Zaheen Knitwears Limited (11497)

12.May.2014

Identified Priority 3 Concerns

Some of the purlins at roof of Building 1 have buckled

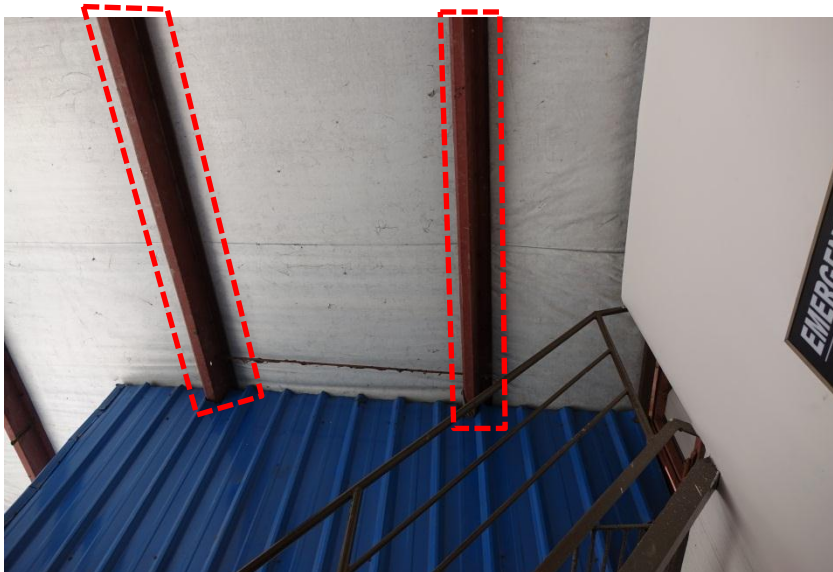
The roof of the Building 1 is currently a steel roof instead of a concrete roof. We noticed that some of the purlins (Z-shaped) have buckled. This is due to the lack of bracing of the purlin.

Suitable lateral bracing should be provided to prevent buckling of these purlin members.

No fireproofing of steel support members for M/F slab at Building 2

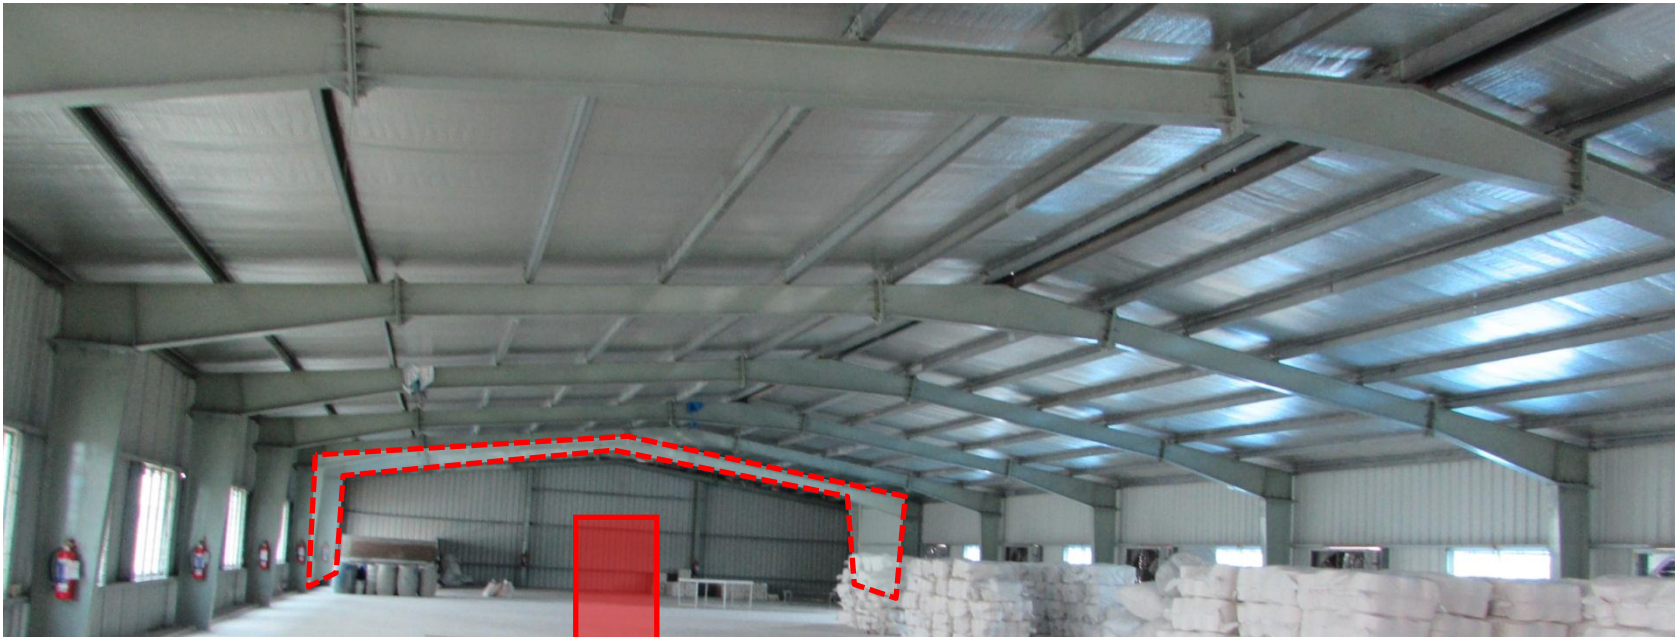
In the garment building 2 (printing), the building mezzanine is a concrete slab with permanent steel formwork, and supported by steel beams and columns. However, it is noticed that the steel beams are not fireproofed in any way.

It is recommended that the floor support system should be fireproofed to at least 1 hour fire resistance period for both flame and heat insulation.
